Service Bulletin

SPECIAL COVERAGE

SUBJECT: Special Coverage Adjustment – Heating, Ventilation, and Air Conditioning Blower Not Fully Functional or Inoperative

MODELS: 2003-2006 Chevrolet Avalanche, Suburban Tahoe
2003-2007 Chevrolet Silverado
2003-2006 GMC Yukon, Yukon XL
2003-2007 GMC Sierra
Equipped with Manual HVAC (CJ3) or Heavy Duty Heater (C42)

1709080

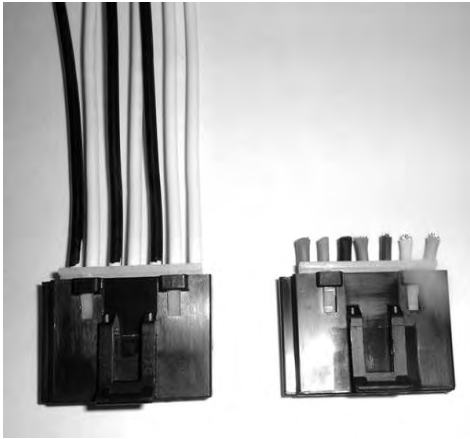
1. Remove the blower fuses (Htr A/C & HVAC 1 fuses).
2. Lower the close-out panel enough to gain access to the resistor module connector.
3. Disconnect the connector from the resistor module.

4. Remove the tape from the wiring harness to expose the wiring.

5. Cut the wires back far enough from the connector to eliminate any melted insulation on the wire.

Note: Use the old connector as a map for splicing the wires for the new connector. Be sure to use the correct crimping tool from the terminal repair kit J 38125. Use only Duraseal splice sleeves. Other splice sleeves may not protect the splice from moisture or provide a good electrical connection.

6. Install the new connector. Use the yellow splice sleeves provided with the connector.
7. Install the new blower motor resistor.
8. Reinstall the fuses. Test the blower motor to make sure all speeds are functional.
9. Reinstall the hush panel/close-out panel.
